X-Ray Tube #1 Warm up Procedure

- 1. Select the manual mode.**
- 2. Select the 3-factor mode.**
- 3. Select table top exposure mode.**
- 4. Select the large focal spot.**
- 5. Select the 200 mA station.**
- 6. Select 250 ms time. (mAs should read 50)**
- 7. Select 80 kVp.**
- 8. Make 5 exposures, @ 30 seconds apart.**

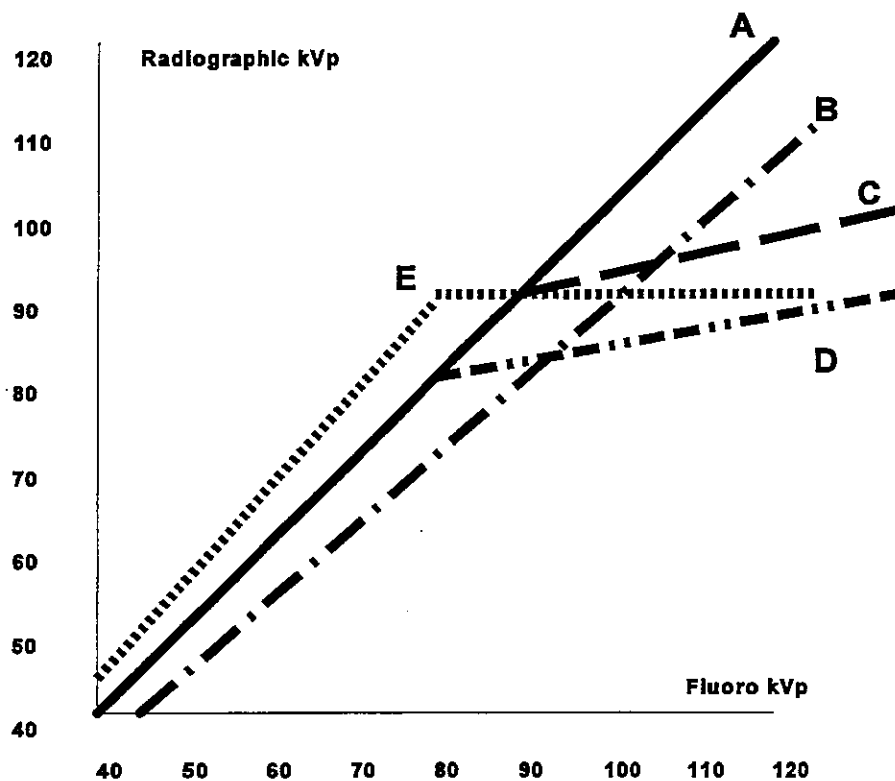
ADDENDUM TO Chapter 4 OPERATION
OF
TM X-RAY GENERATORS
MAINTENANCE MANUAL 9026.251
